# Botley West Solar Farm

## Applicant's Response to the ExA's First Written Questions

PINS Ref: EN010147

Document Ref: EN010147/APP/12.2 Rev P0

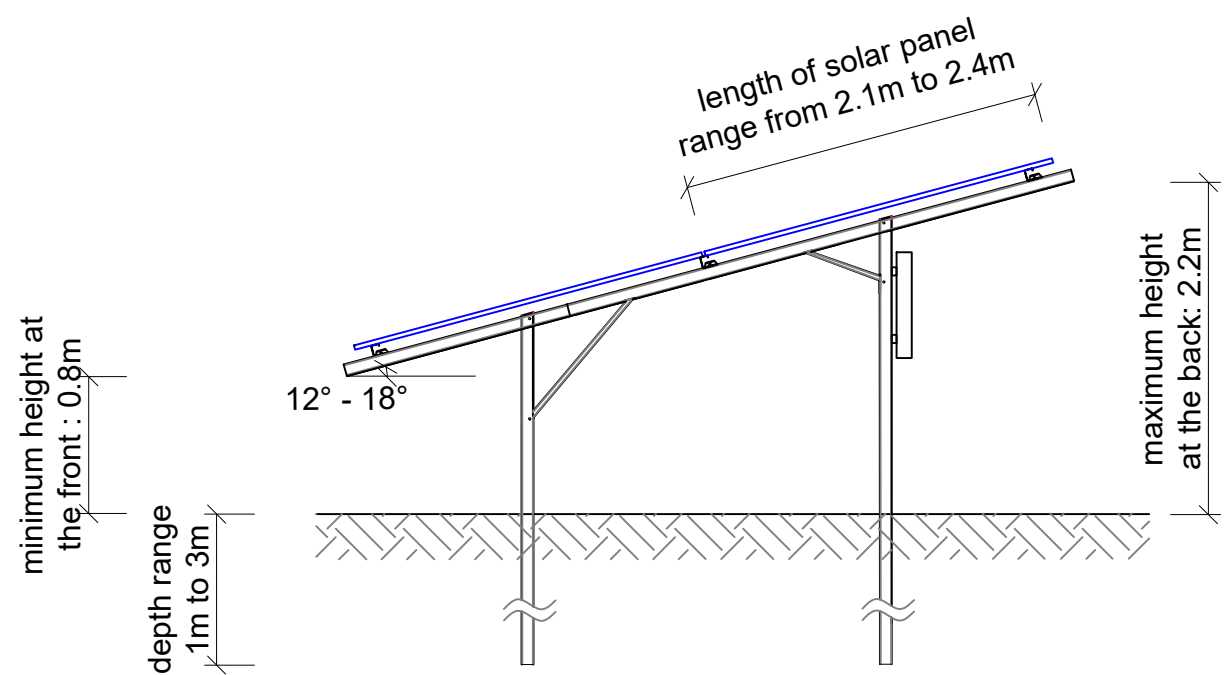
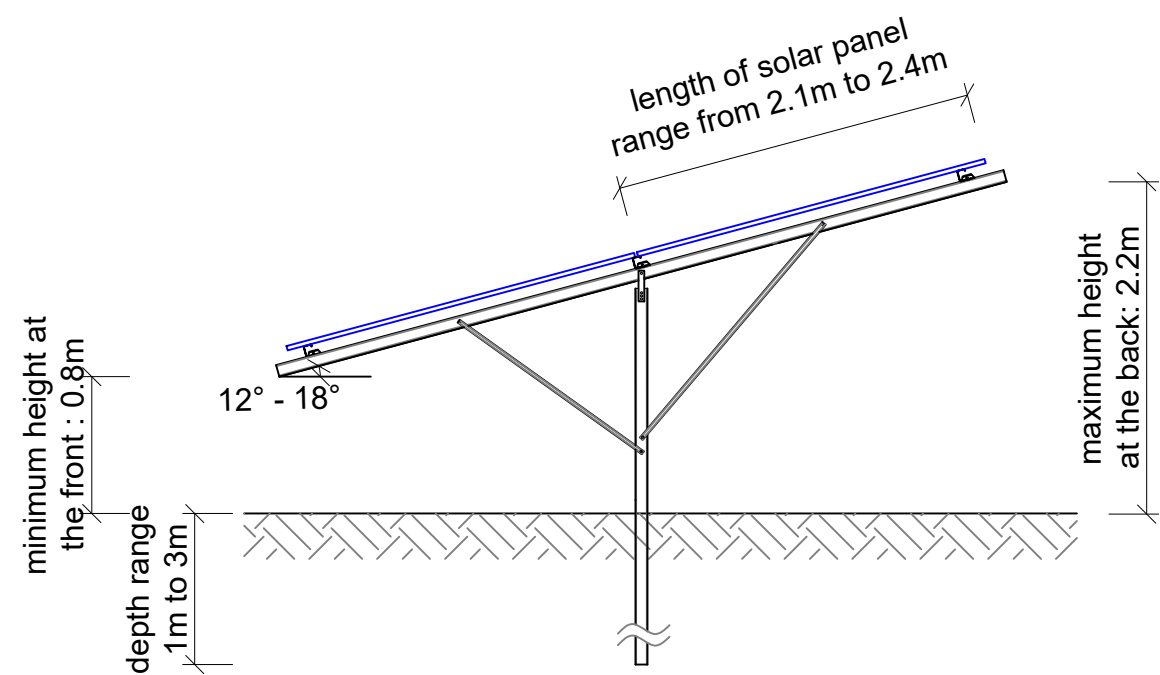
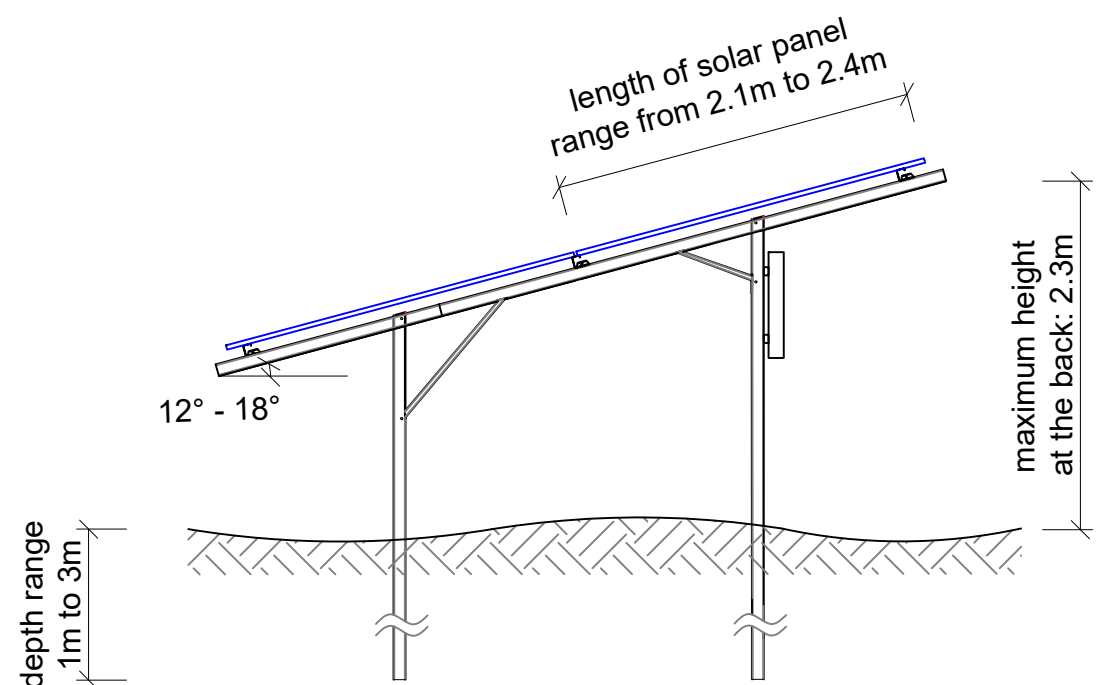
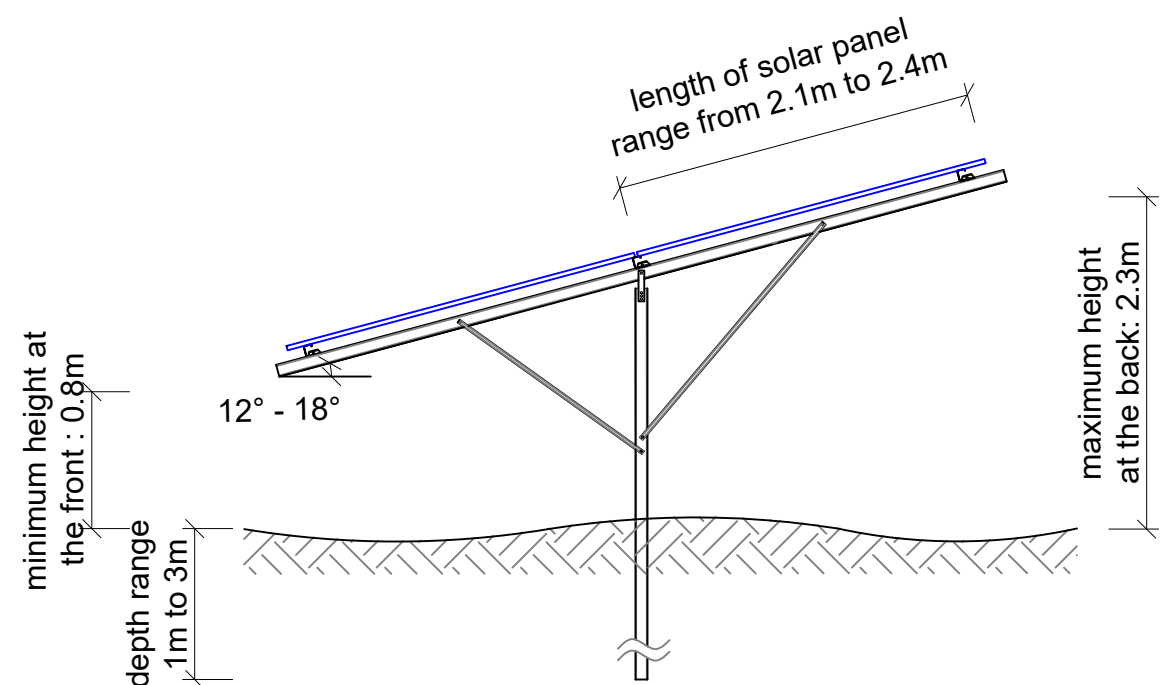
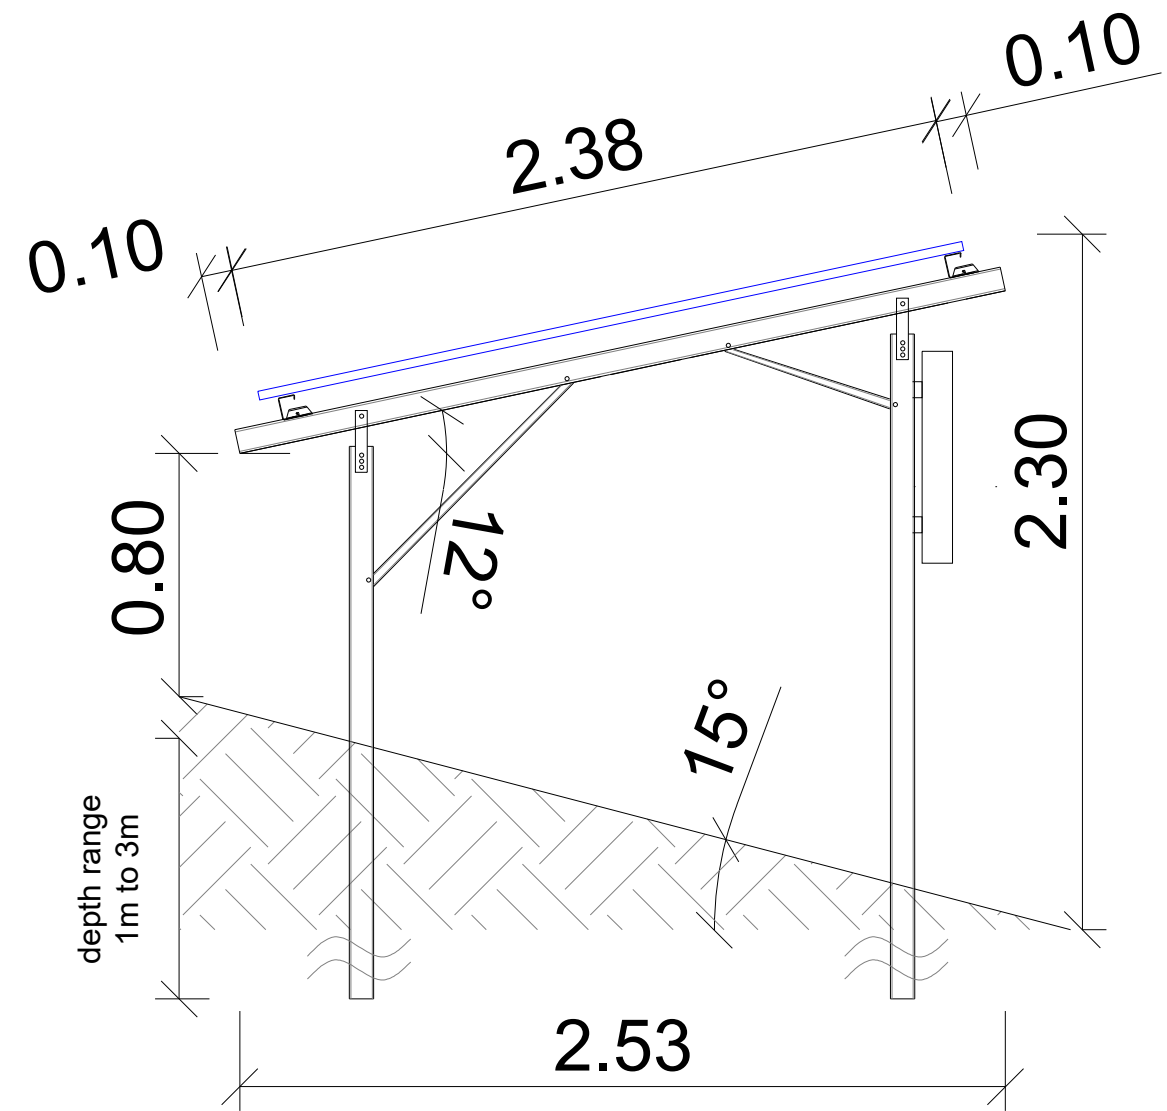
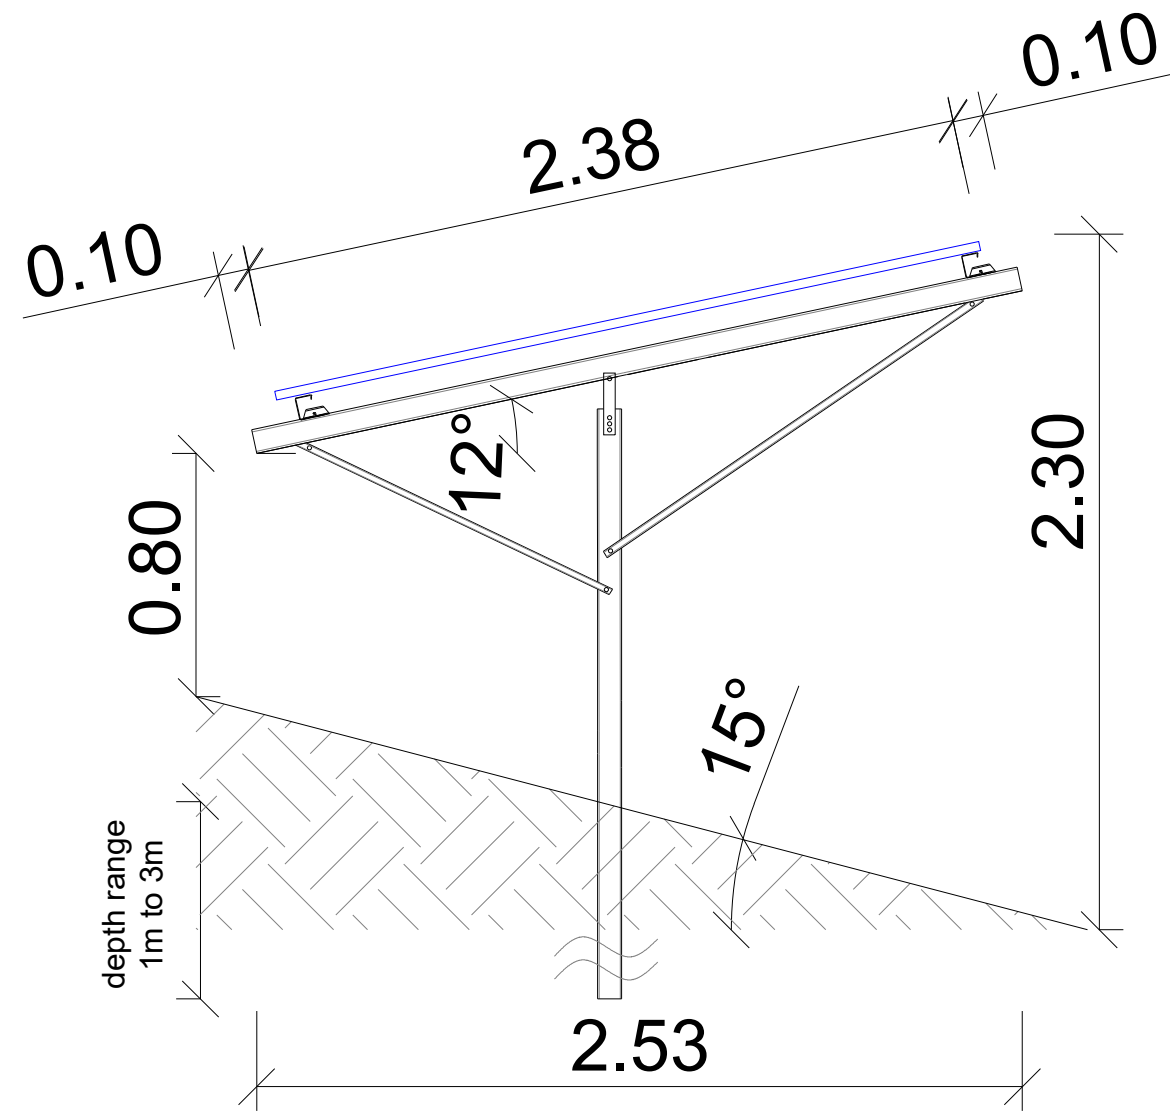
| ExQ1          | Question to | Question   | Applicant's Response  |
|---------------|-------------|--|---|
| <b>Q1.1.7</b> | Applicant   | <p><b>Number of Piles and Worst-Case Design Scenario</b></p> <p>The ExA appreciates that the number of panels likely to be installed is not yet finalised and that this number would ultimately impact the total number of piles. However, it would help the Examining Authority's (ExA's) understanding if the Applicant could provide a plan detailing the number of piles for various design scenarios. The plan should also detail other factors which may have an environmental impact such as pile depth. Following on from this plan, for the Environment Statement (ES) chapters where piling is considered to have a potential impact, the Applicant should provide an explanation on which design option they have chosen to represent the worst case.</p> | <p>The pile number and depth are not fixed at this stage due to ongoing detailed design work and micro-siting. However, a range of indicative parameters are presented in ES Chapter 6 [APP-043], Table 6.3, and section 6.4.2:</p> <ul style="list-style-type: none"> <li>• Indicative Foundation Type: Driven piles or screw piles</li> <li>• Indicative total number of piles: 780,000 to 1,600,000</li> <li>• Depth of piles below ground level (m): 1.0 m to 3.0 m</li> <li>• The Pile type and density will vary according to soil conditions, topography, and panel layout.</li> </ul> <p>To ensure a precautionary approach, a worst-case scenario was adopted, based on a two-leg design option at each end, and which was assessed and reported in the ES. This scenario assumes an upper limit of 1,600,000 steel piles driven to a depth of 3 meters using pile-driving methods.</p> <p>Please refer to the <b>Appendix 7</b> Q1.1.7 Illustrative Mounting Structure Plan for the design scenarios.</p> |

| ExQ1    | Question to | Question   | Applicant's Response  |
|---------|-------------|--|---|
| Q1.1.19 | Applicant   | <p><b>Solar Panel Mounting Mechanism</b></p> <p>In ES Chapter 6 [APP-043] paragraph 6.4.10 describes the solar module mounting structure as being a metal framework, supported by galvanised steel piles or screws, with a worst-case assumption of two legs at each end.</p> <p>To understand the likely number and distribution of piles and the orientation of these panels in differing gradients, provide an indication of how many individual solar panels will fit onto one section of framework, accompanied by scaled elevations, sections and plans that describe a typical block of panels on varying land gradients.</p>   | <p>Each mounting table will support 26 panels in a 13x2 landscape configuration and be supported by piles, with all structures designed to remain within the assessed parameters set out in Chapter 6 of the Environmental Statement [APP-043]. Panel dimensions, table spacing, pile depth, and total number of piles fall within the ranges assessed in Table 6.3, and mounting heights will comply with the fixed limits of 0.8 m (lower edge) to 2.3 m (upper edge), including on sloped ground. Please refer to the Appendix Q1.1.7 Illustrative Mounting Structure Plan.</p>  |
